PANAMA CANAL AUTHORITY	VARIATION	PAGE 1 OF 4
1. REQUEST FOR PROPOSAL No.: RFP-76161	2. CONTRACT No.: CMC-221427	3. DATE: January 25, 2013
		4. VARIATION No.: 061

Variation No. 061 is issued to change the Contractor's limits as follows:

Design and Construction of the Third Set of Locks

5802-28

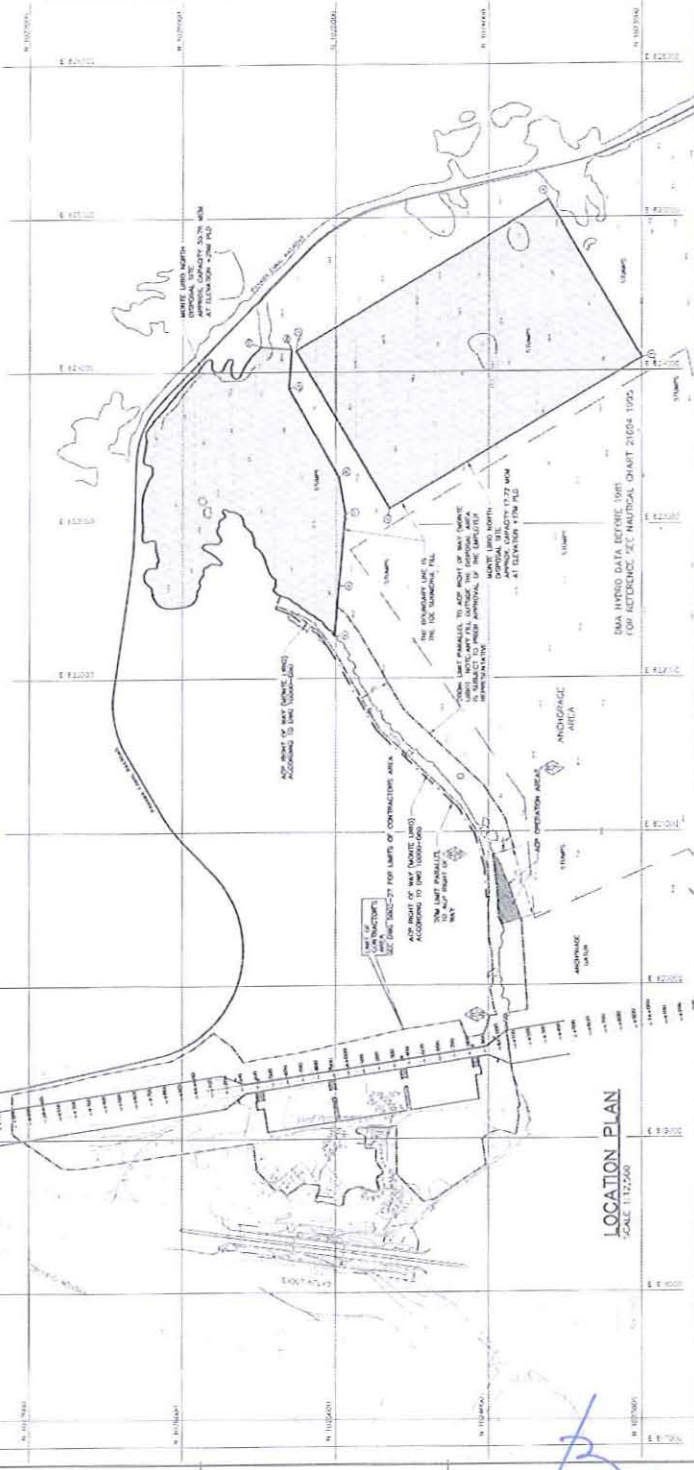
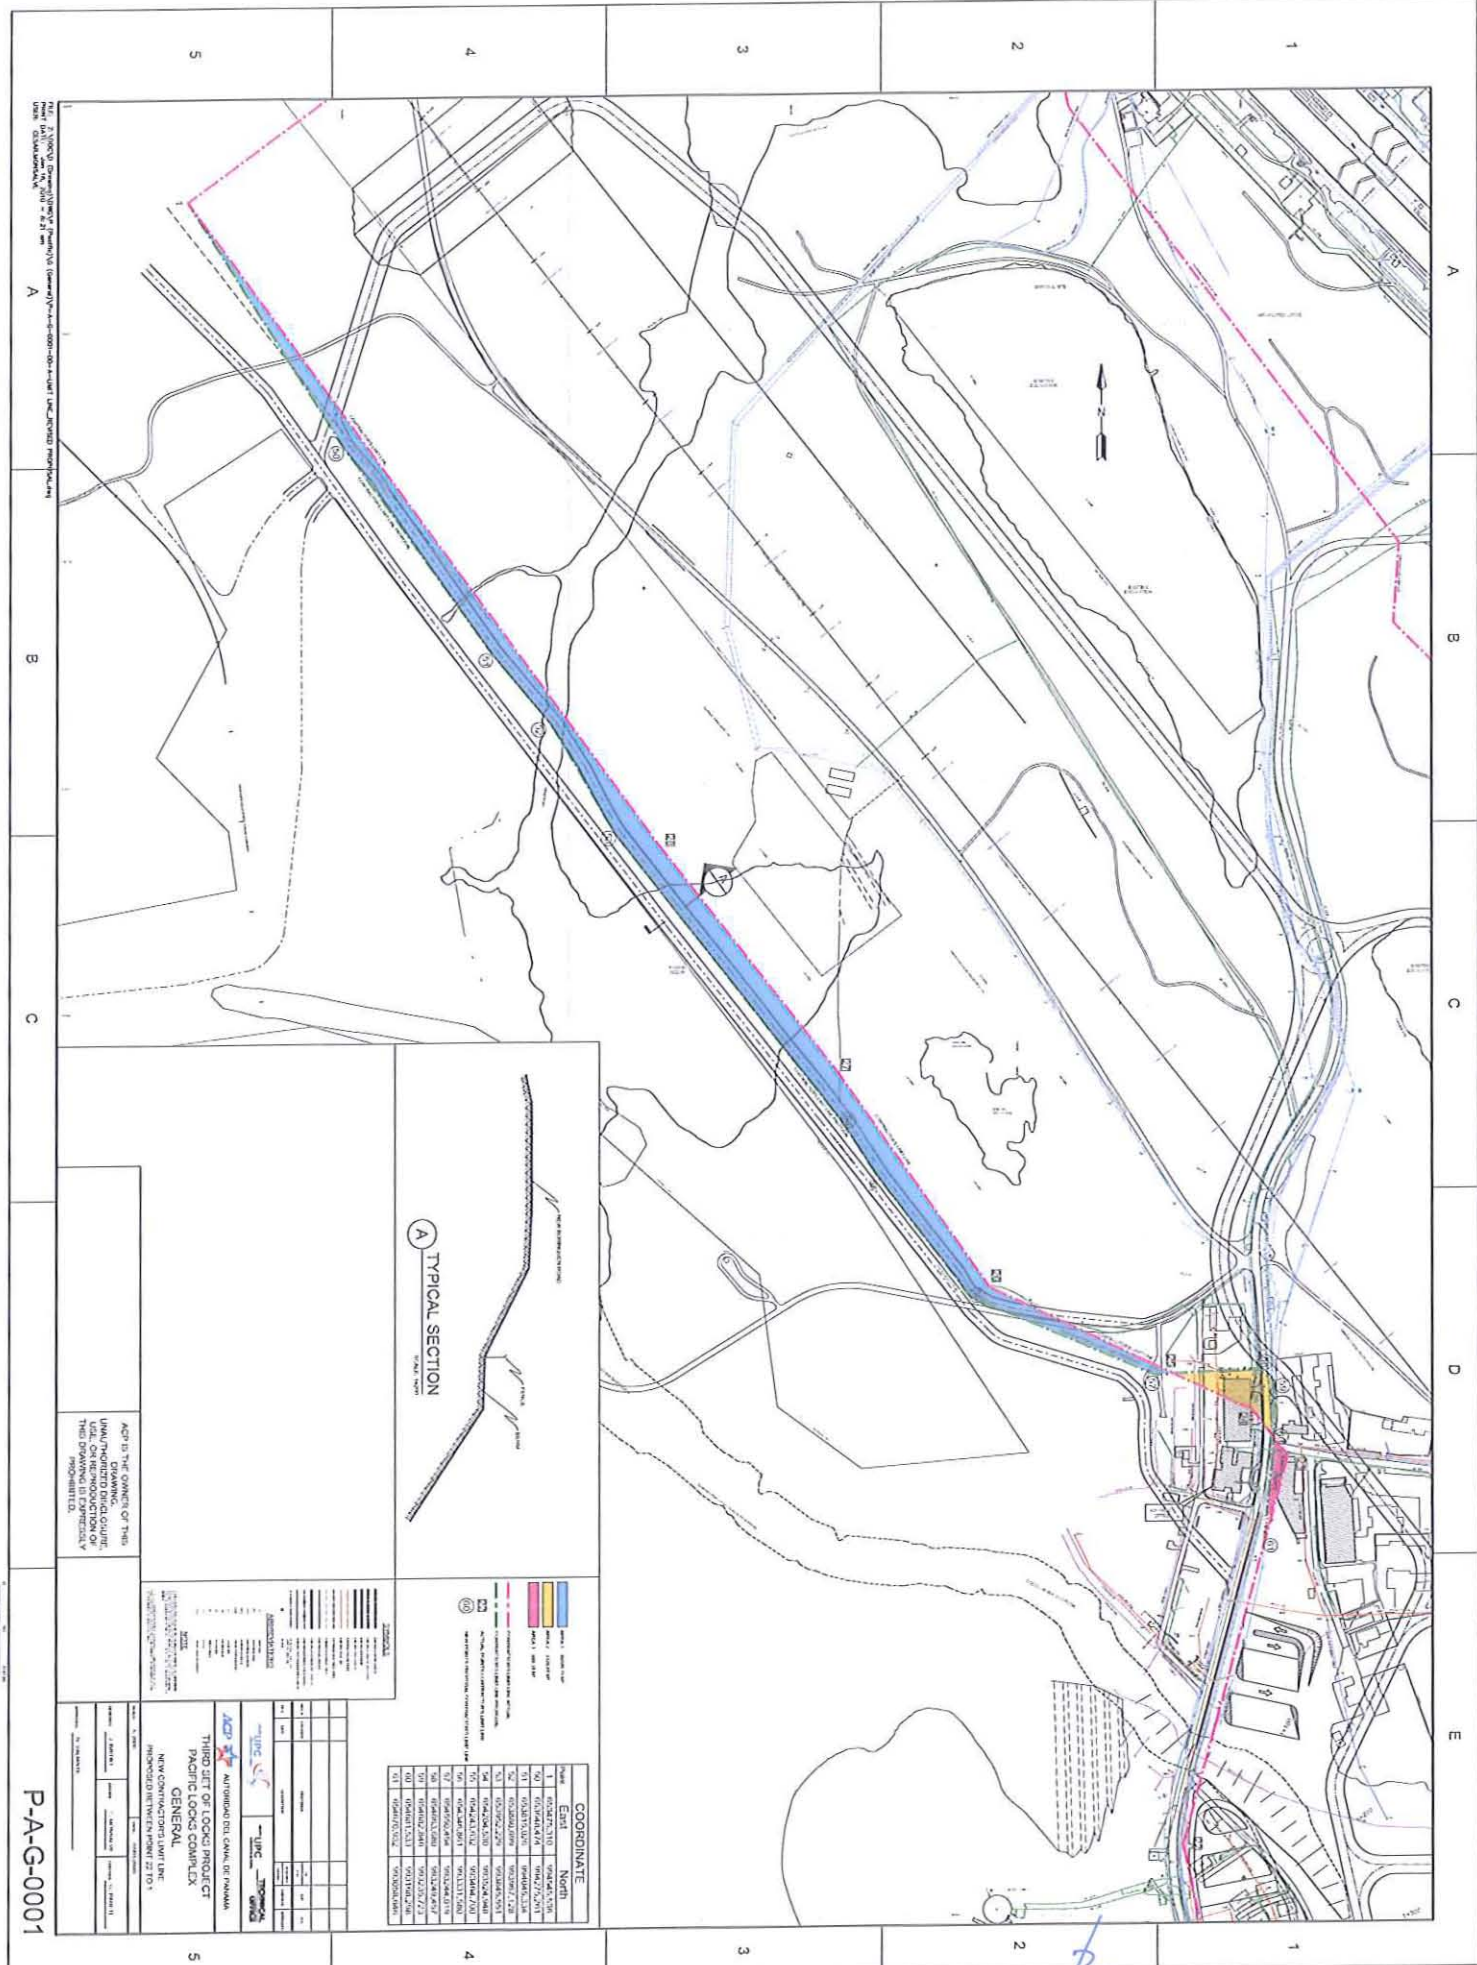
4. Reflect the new configuration of Mindi A Disposal Site as defined by the coordinates depicted in the attached revised Drawing No. 5802-28. The new configuration is a result of the following:

- Contractor's release of part of the Mindi A Disposal Site referred to as Zone A. Therefore, this area is no longer part of the Contractor's polygon.
- Extension of the Mindi A Disposal Site Northward.
- Employer's consent for the use by the Contractor, of an Offshore Disposal Area for the dredged and salt water contaminated materials

Before any work is initiated in the above granted areas, the Contractor must comply with the quality, safety and environmental requirements established in the relevant Sections of the Employer's Requirements

P-A-G-0001

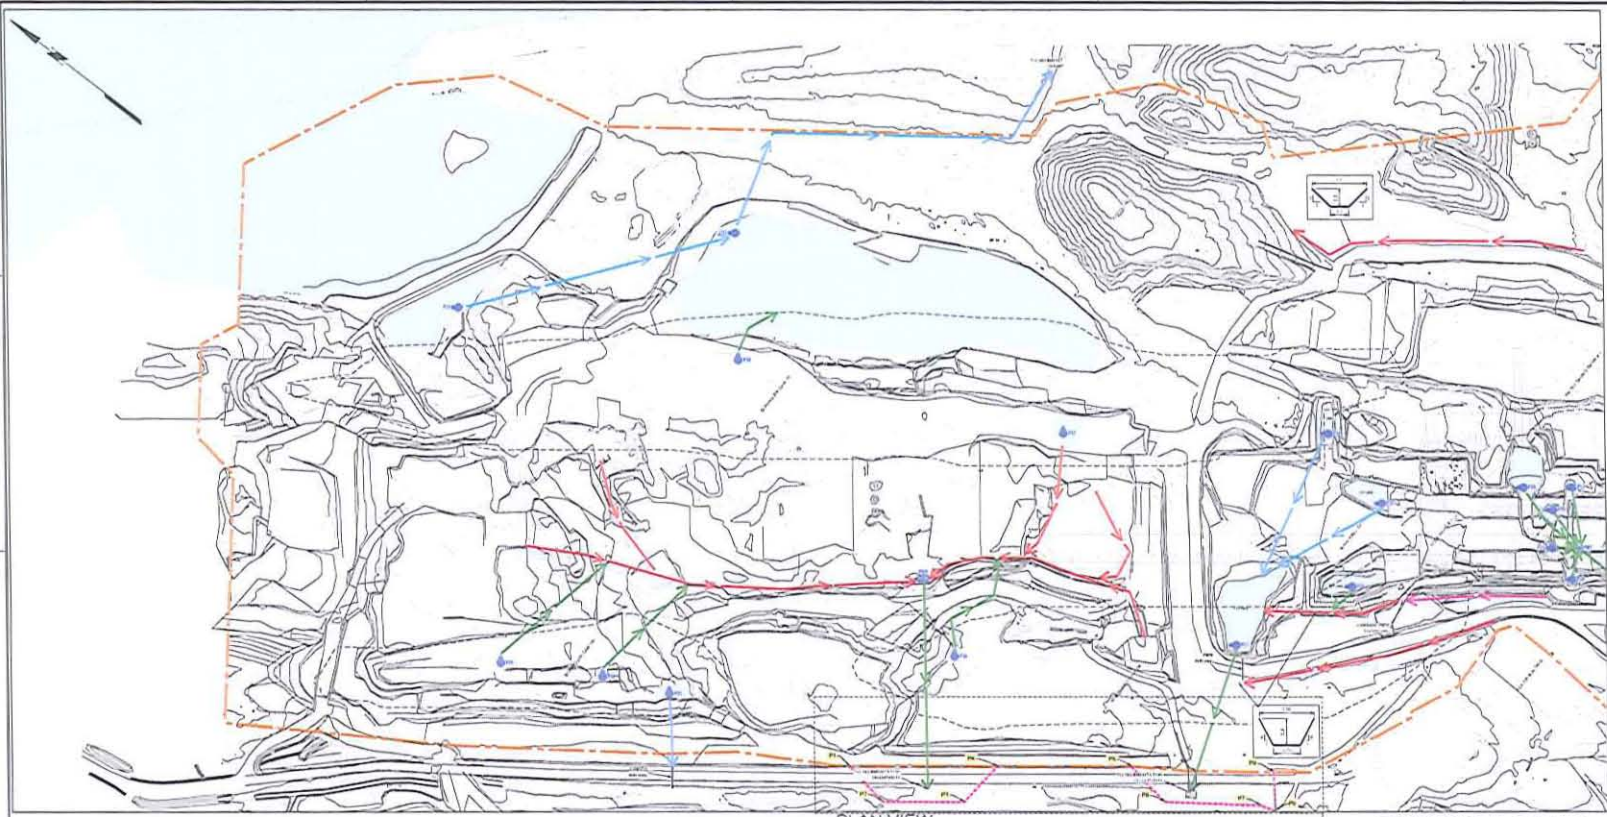
3. Change the Contractor's limits to include the area of Building 12R85 and maintain the parking area of the Employers Office (Cocoli) outside the Contractor's limit. The area is depicted on the attached Drawing P-A-G-0001 as defined by the following coordinates:

If the Contractor intends to use the existing light service road located on the berm, adjacent to the new Borinquen Road (Section A of Drawing P-A-G-0001), as a haul road, the necessary calculations shall be submitted to the Employer indicating the road is adequate for this use. The Contractor shall ensure at all times the integrity of the Borinquen Road and comply with the requirements established in the relevant Sections of the Employer's Requirements.

SK-P-A-0264

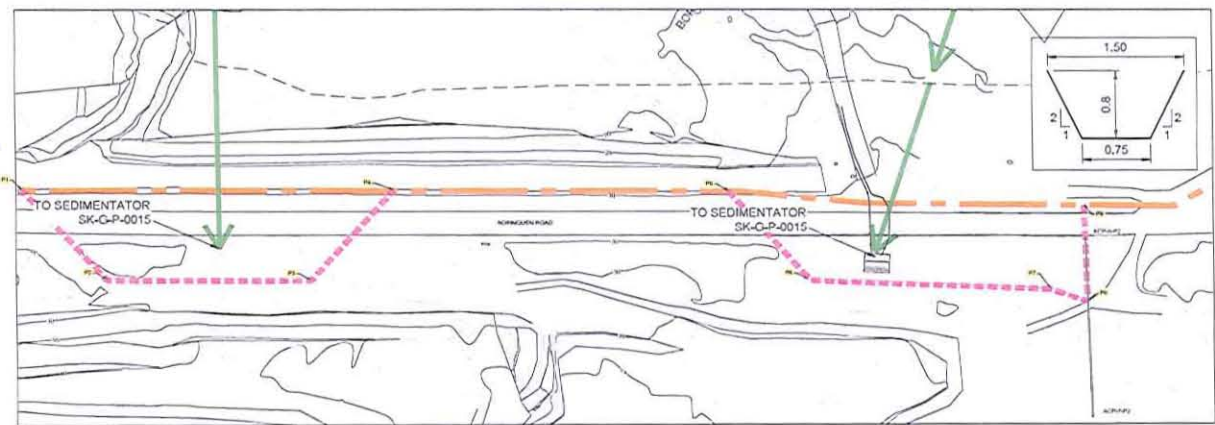
2. Extend the Contractor's limits to the areas depicted on the attached sketch SKE-P-A-0264, areas required to install a sedimentation pond and sedimentation traps as part of the Contractor's dewatering system. The areas are bounded by the following coordinates:

Before any work is started in the above areas, the Contractor must comply with the requirements established in the relevant Sections of the Employer's Requirements and additionally ensure that the stability of the slopes of the Borinquen Road will not be compromised.
